STRAWBERRY PARK RESIDENCE
STEAMBOAT SPRINGS
COLORADO

PLAN REVIEW COMMENTS

Job Address: tbd
Applicant: PF Wall, LLC.

Plan Log No. CB-06-438
Designer: CCA

FOOTING SCHEDULE FOR SECTION 5/S-2

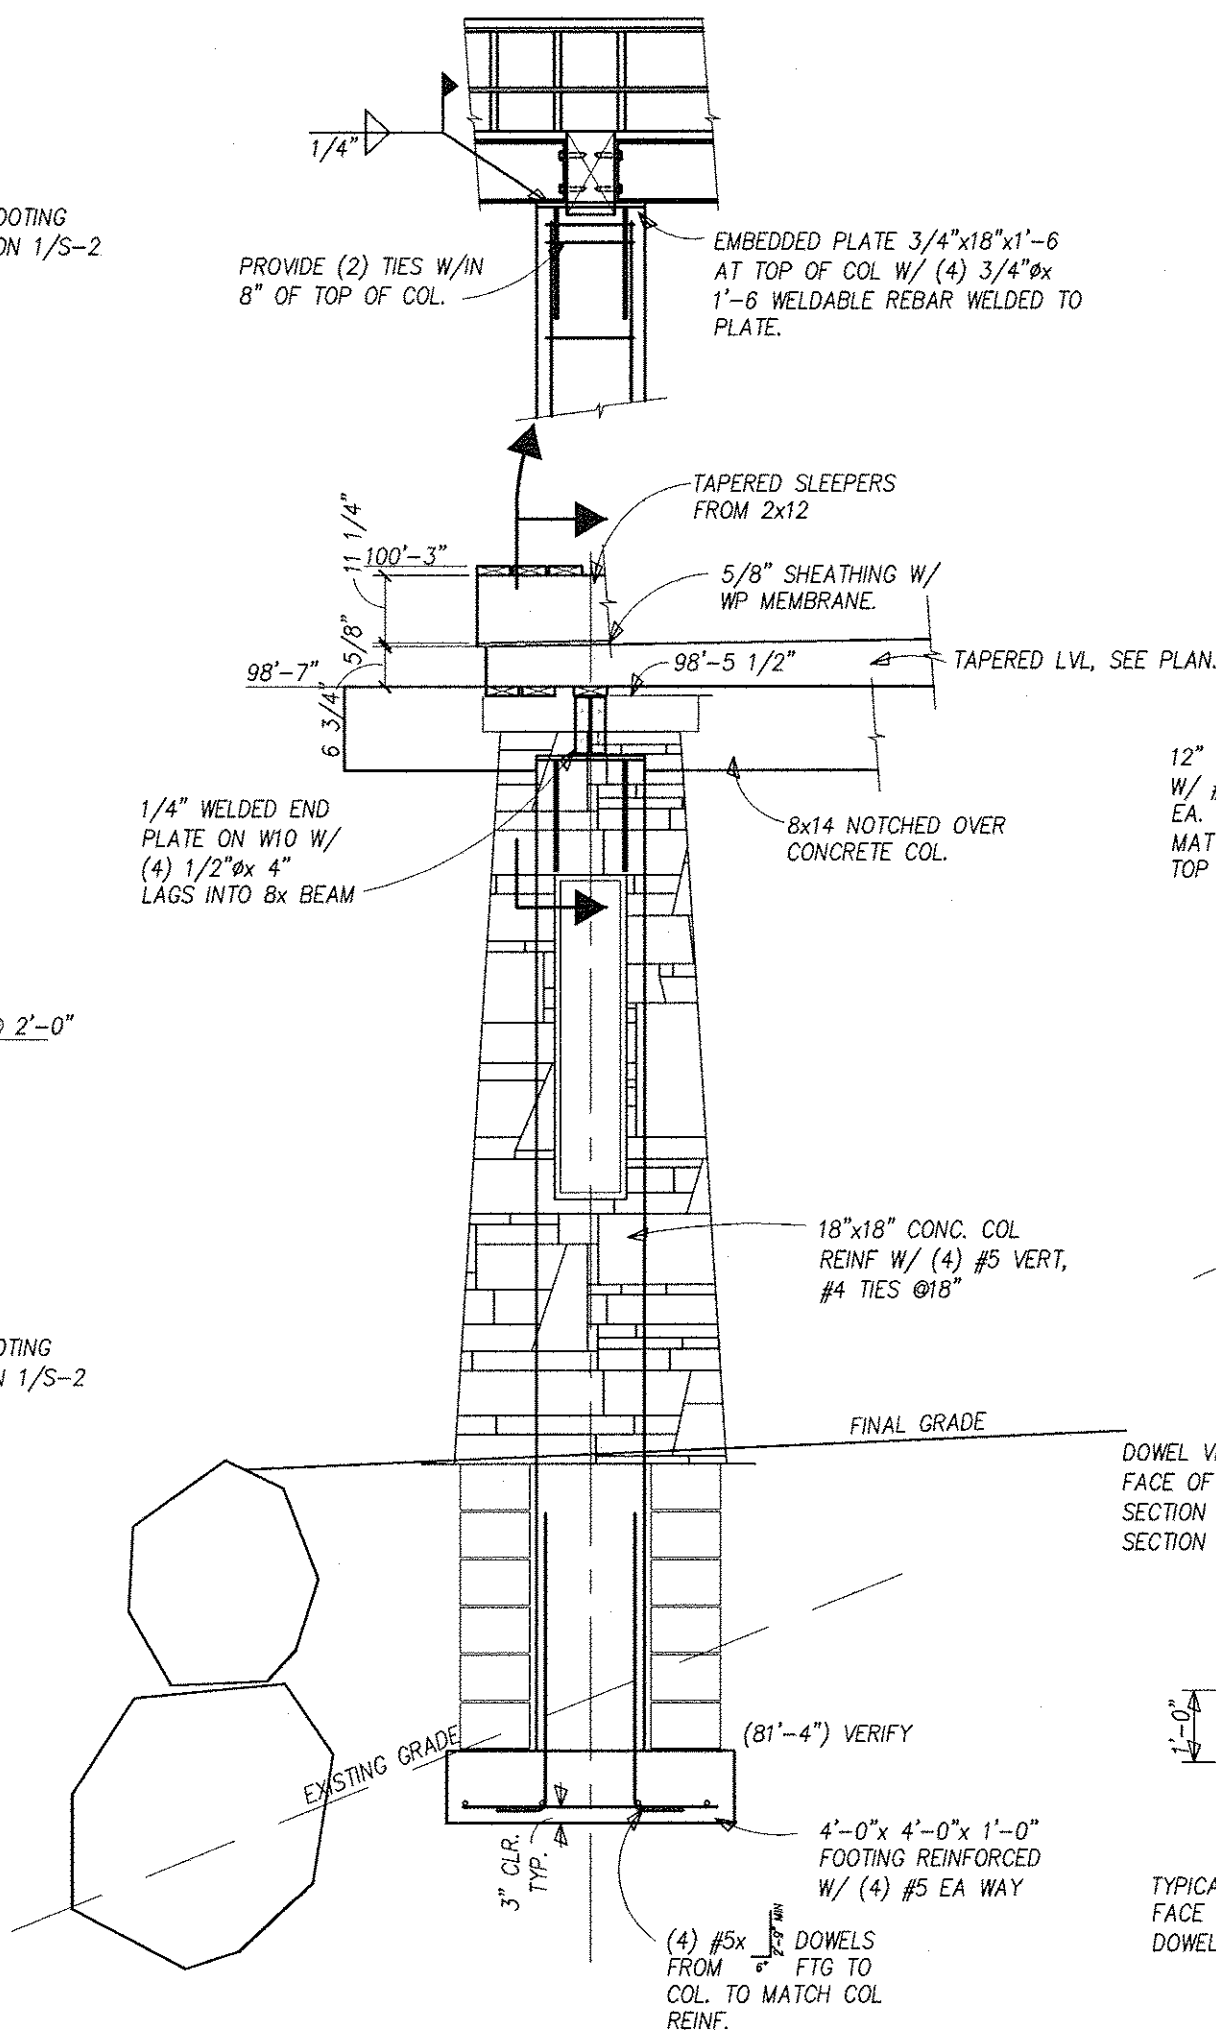
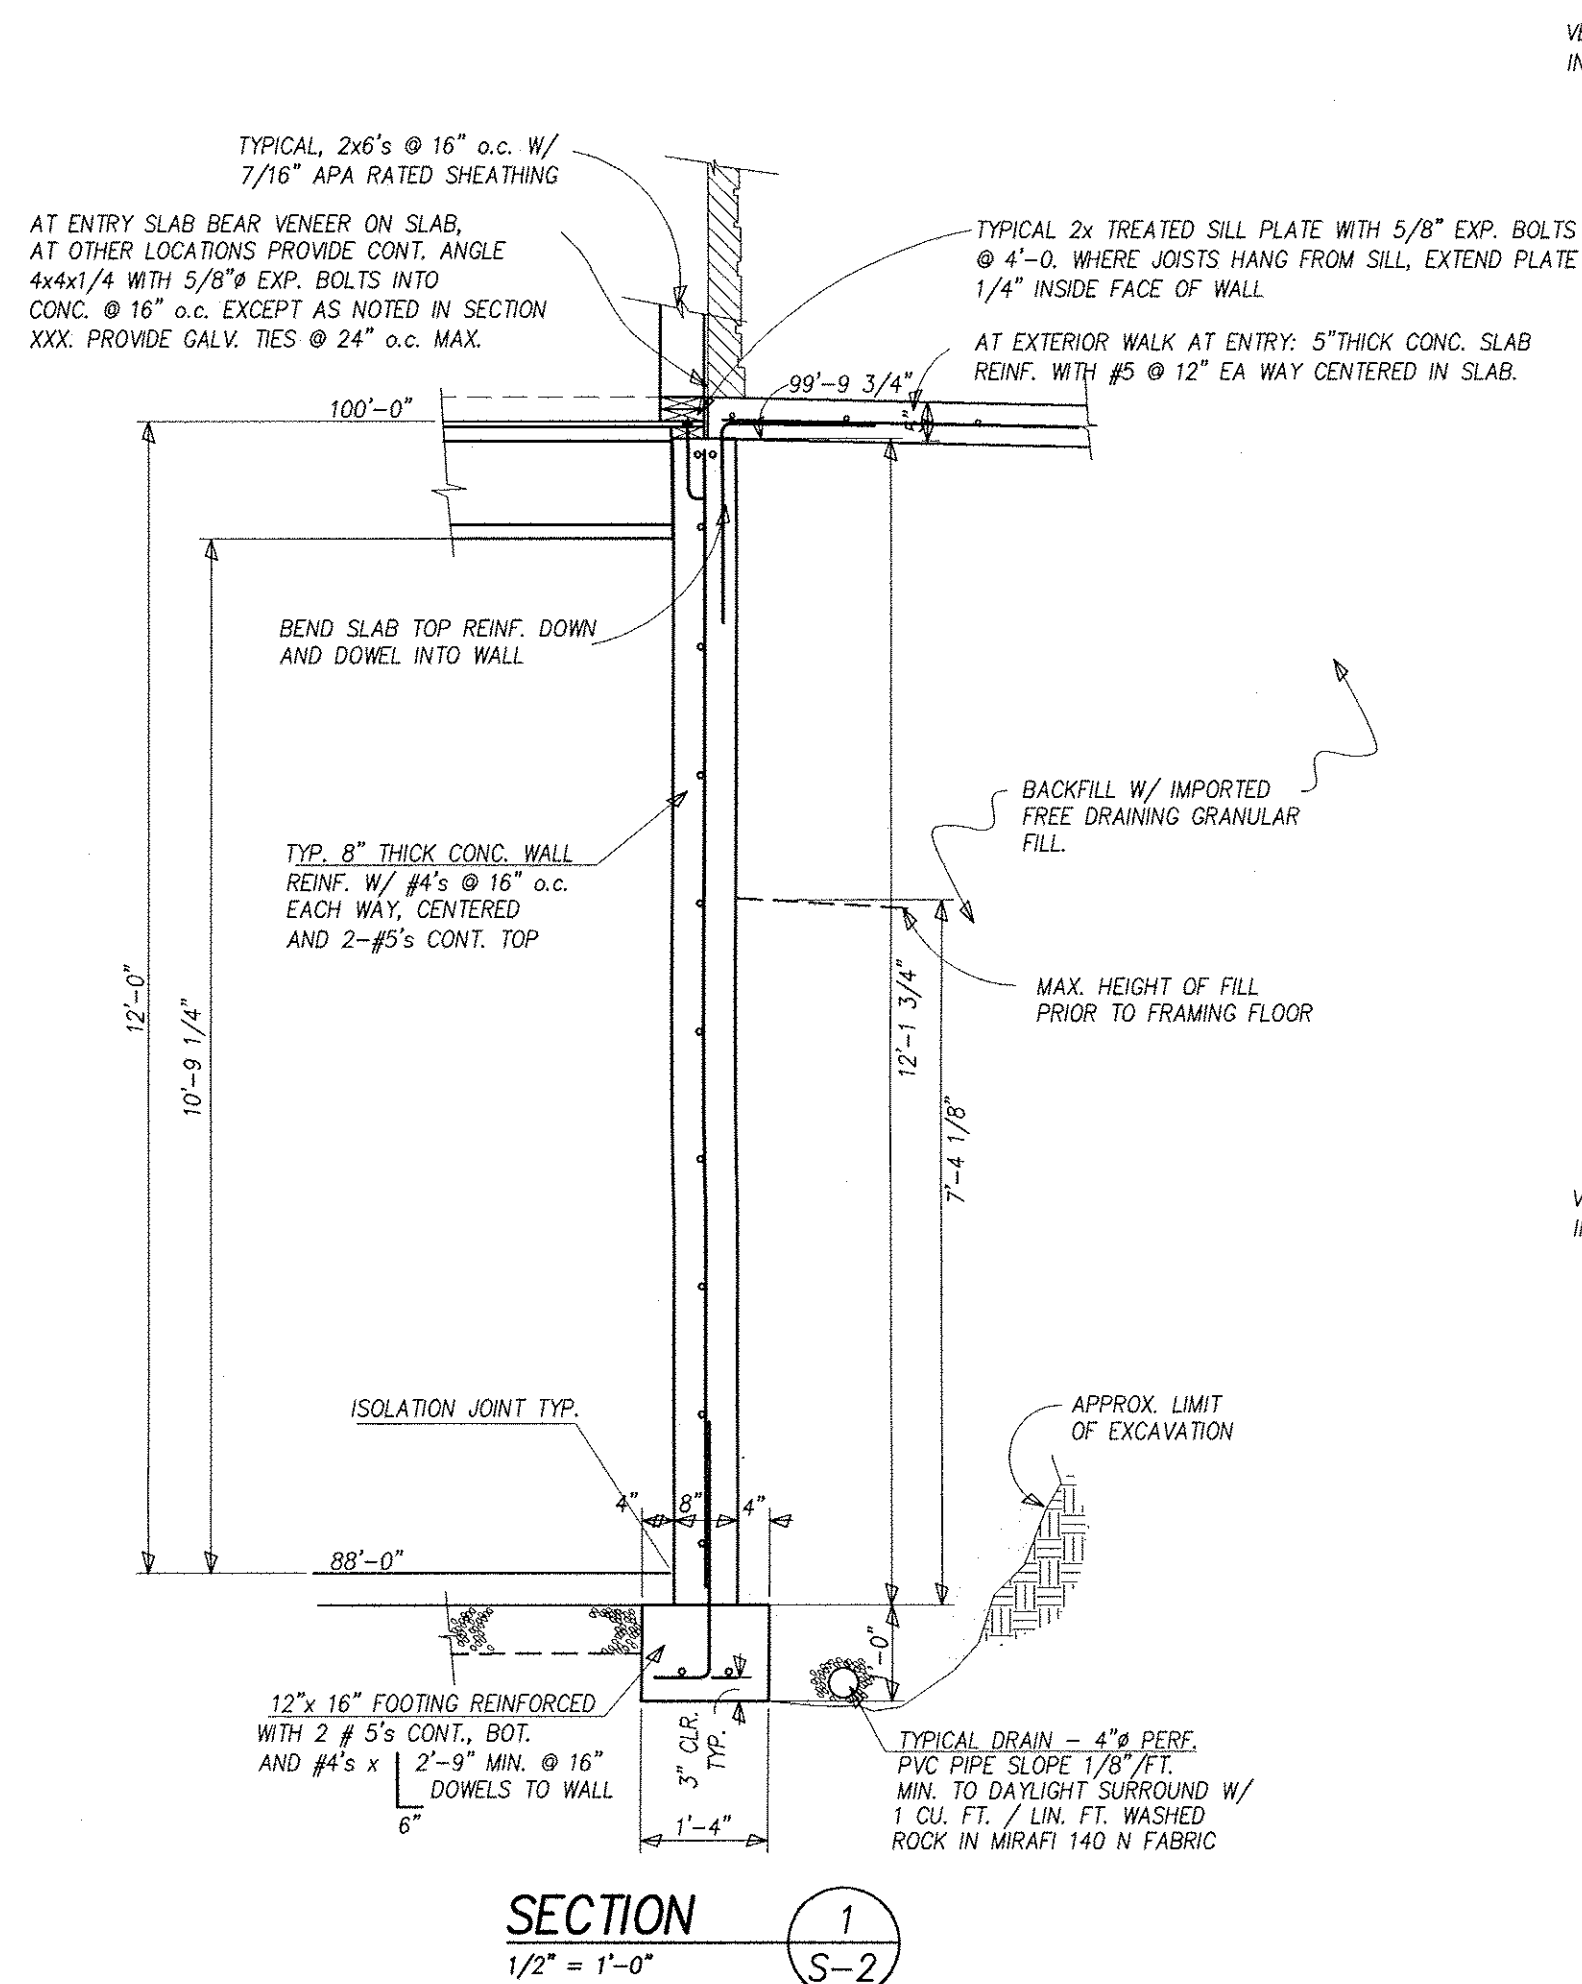
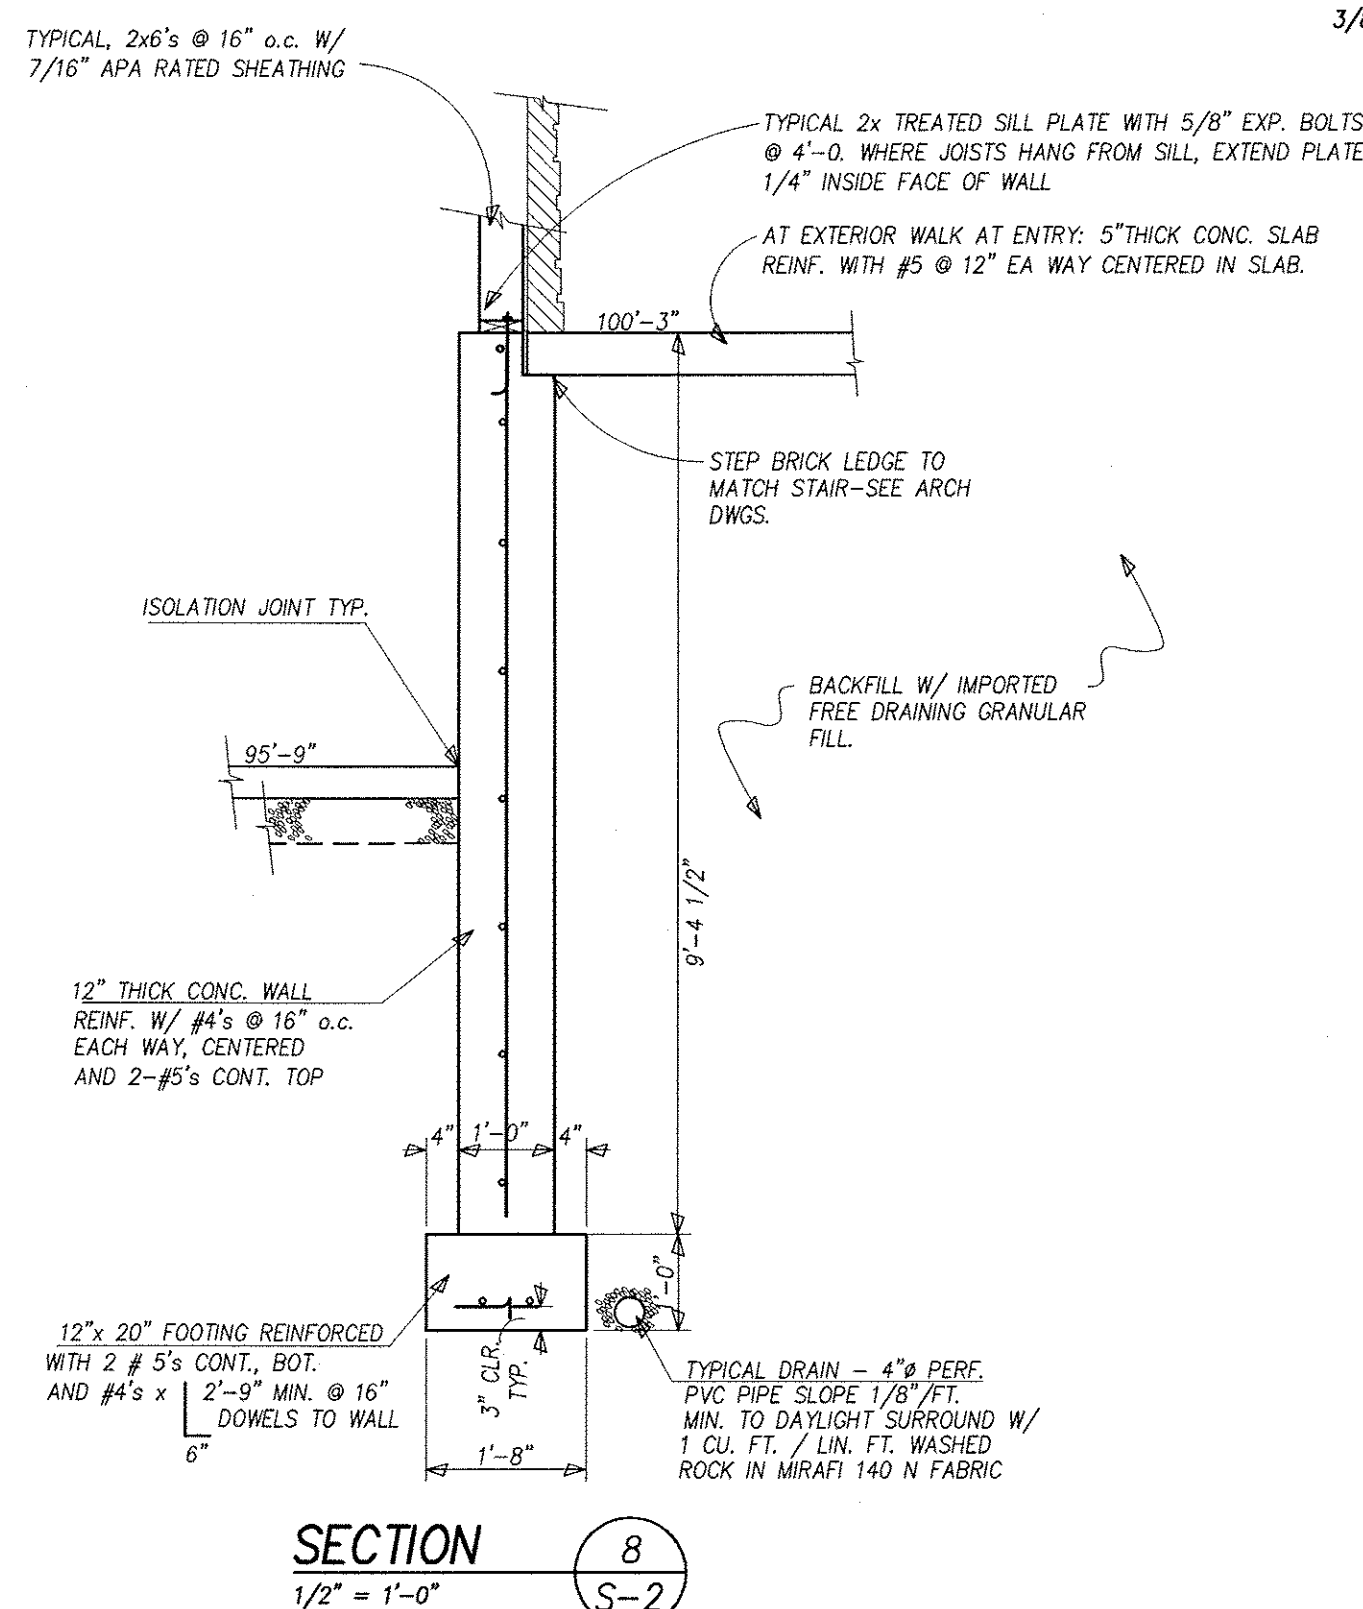
1. Remove the words "Foundation only" for a full permit.
2. Provide an engineered design for retaining walls greater than 4' high. 8/S2.
3. Show how you will provide supply air to the media room.

1. Foundation Only has been removed from the full set of structural drawings issued for full permit.
2. A retaining wall design for walls up to 10 feet has been provided.
3. A note has been added to the plans stating that the media room will receive light and ventilation per code minimums via artificial light and a HRV.
4. The fireplace specified is 5 piece modular conc. unit manufactured by Contempo Fireplaces, Alb, NM—A cut sheet, install manual and manufacturer details are contained in this document. (attached)
5. Manufacturer specs have been attached for the cable rails and details in plan set now reference this Manufacturer.
6. See item 4.
7. Complete structural drawings have been provided.
